REVISED RESPONSE TO REQUEST FOR ADDITIONAL INFORMATION

APR1400 Design Certification

Docket No. 52-046

RAI No.: 116-8054
SRP Section: 14.03.08 – Inspections, Tests, Analyses, and Acceptance Criteria
Application Section: 14.03.08
Date of RAI Issue: 07/27/2015

Table 2.8-2

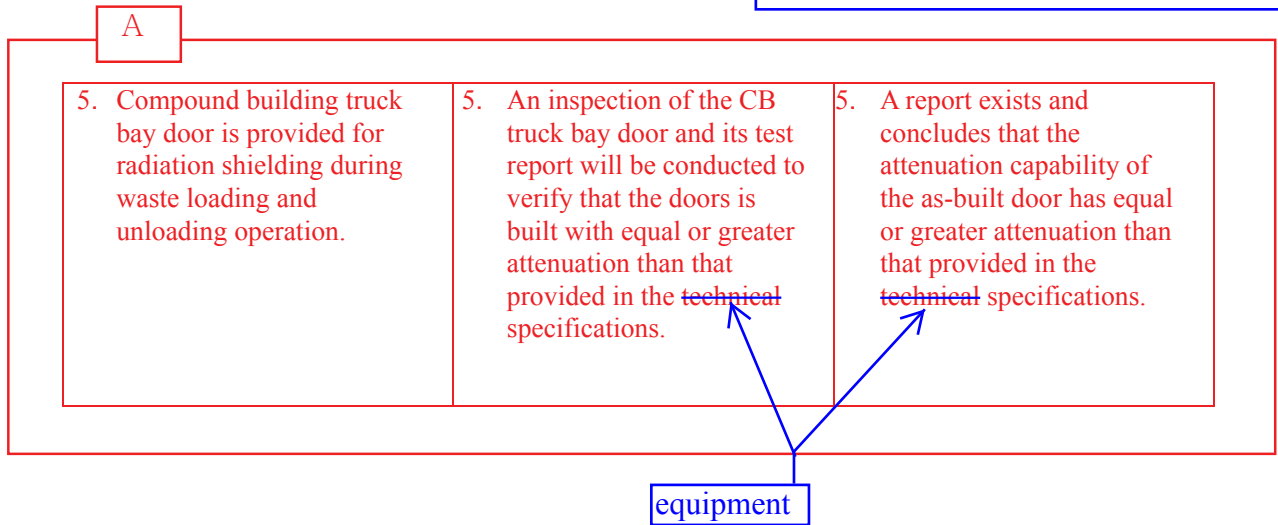
Tier 1, Table 2.8-2, "Radiation Protection ITAAC," item 1, is associated with radiation shielding. The acceptance criteria indicates that a report exists which verifies that radiation levels are within those levels specified in Tier 1, Table 2.8-1. Table 2.8-1 only provides the dose rate range for each zone designation and does not provide the specific zoning for any of the rooms in the plant. Therefore, there is no way for anyone to verify that this ITAAC has been completed during facility construction. In addition, Tier 1, Table 2.8-2, item 1, indicates that the plant will be built and then a report will be completed to determine that radiation zoning requirements are met. Therefore, Tier 1, Table 2.8-2, Item 1, is written as a design acceptance criteria (DAC), instead of an ITAAC. It is unclear why a DAC would be needed for radiation shielding when Tier 2 already provides minimum radiation shielding thicknesses for radiation sources large enough to require shielding.

Therefore, Tier 1, Table 2.8-2, item 1 is unacceptable. To provide appropriate ITAAC for radiation shielding, staff suggests the following:

1. The applicant should modify or replace Tier 1, Table 2.8-2, item 1 with an ITAAC to verify that minimum shielding requirements are met for significant radiation sources which require radiation shielding. Using this approach, Tier 1, Section 2.8 and item 1 in Table 2.8-2 should provide the shielding material for each room (for example, concrete) as well as the thickness of each shield, for significant sources which require shielding.

1. KHNP will revise the ITAAC in Table 2.8-2, item 1 to reflect an inspection and analysis based on the type of construction material used for the shielding and the [thicknesses](#) of the floors and walls for rooms that contain significant radiation sources which require shielding.

the minimum shielding requirements for significant radiation sources which require shielding

materials of construction and the thickness of all shield walls and floors are as-built for confirmation of the

in accordance with the shield barrier drawings

the shielding materials and the thicknesses of walls and floors are as-built for the shielding of all radiation areas
